DPD PROJECT No: 3013130
1099 STEWART STREET + 1050 HOWELL STREET

Design Review Board Recommendation Meeting
4 DECEMBER 2012

06. DEPARTURE 2 - LOADING

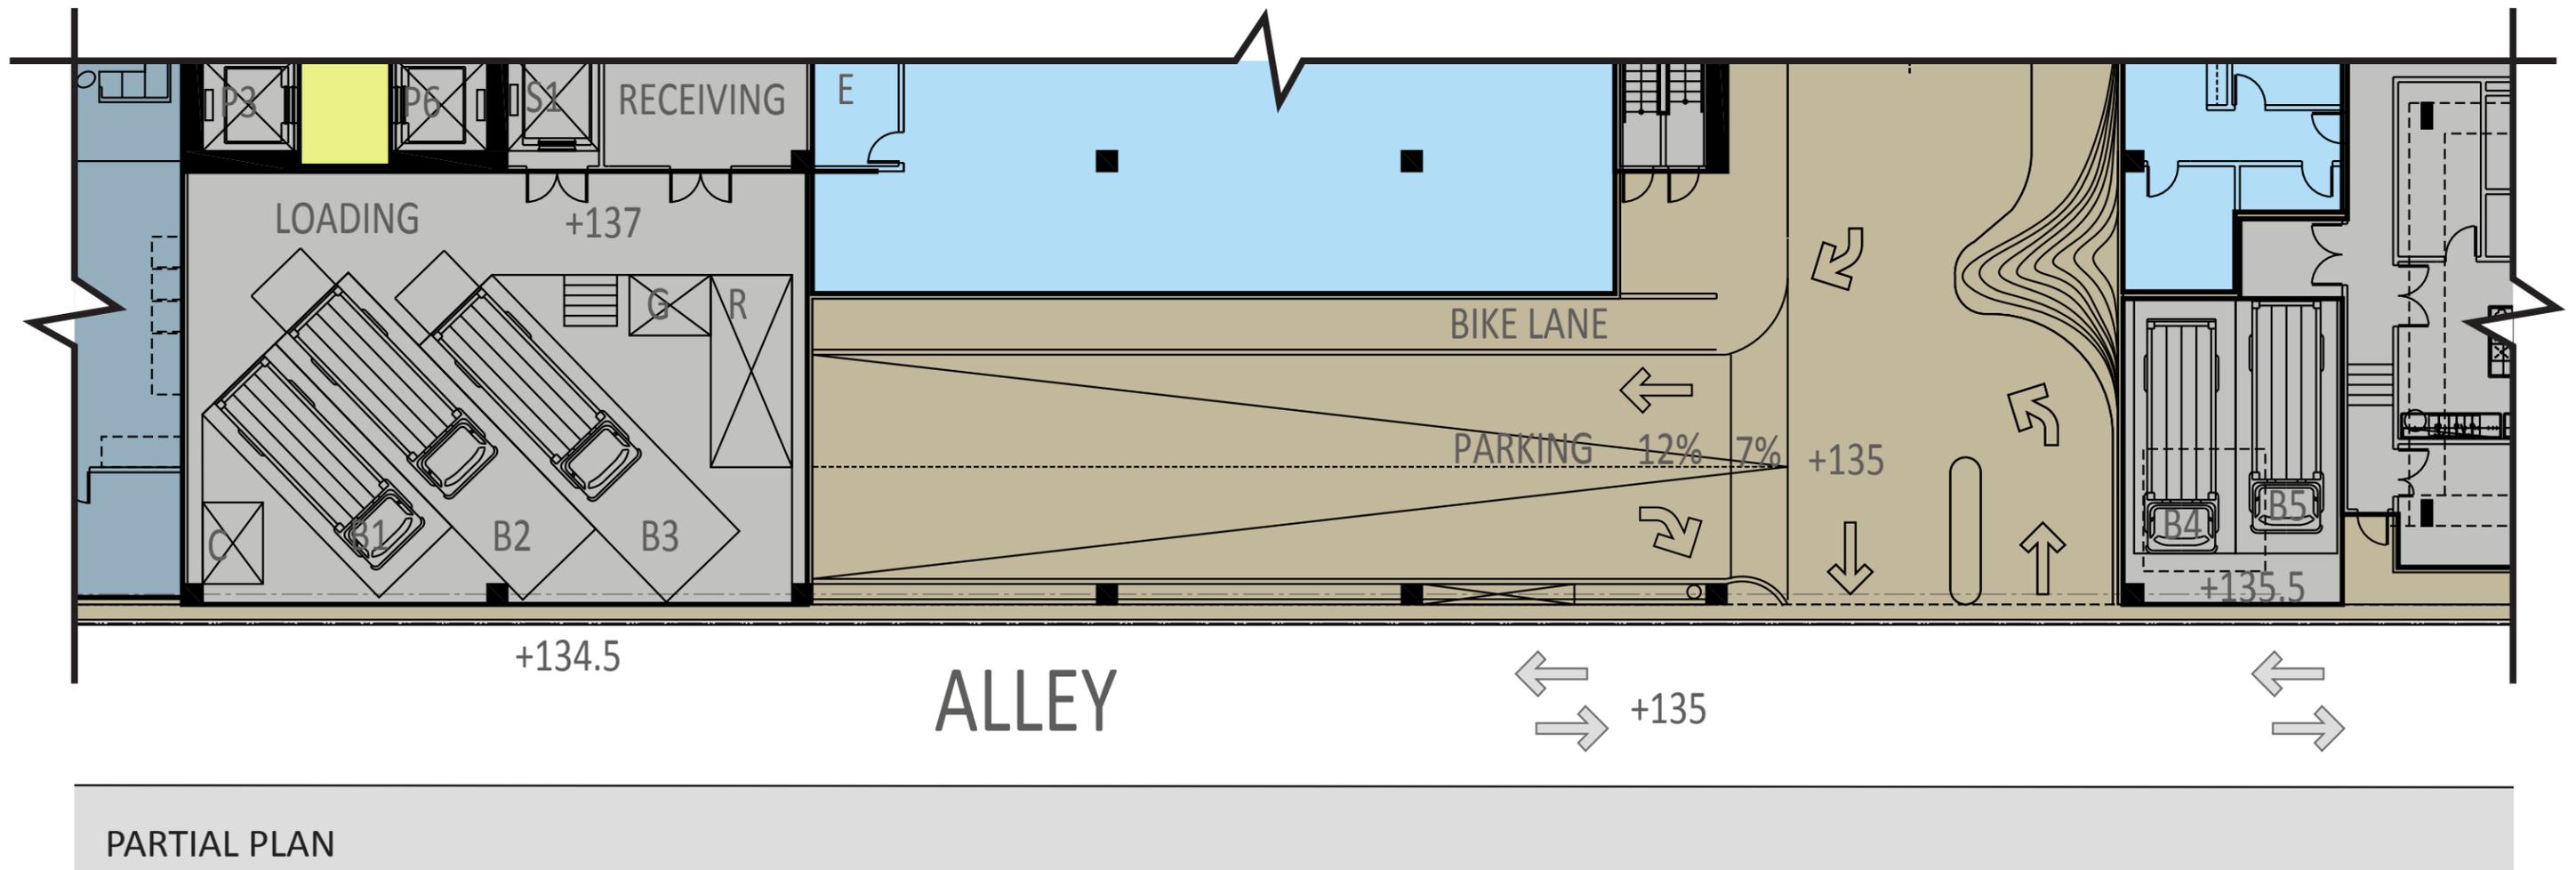
Low Demand Use **388,002 TO 520,000 SF** **5 Loading Berths**
Required @ 35'

The two 35' bays and three 25' bays provided are adequate to meet projected demand.

The project provides (2) loading berths of 35' in length and (3) loading berths of 25' in length.
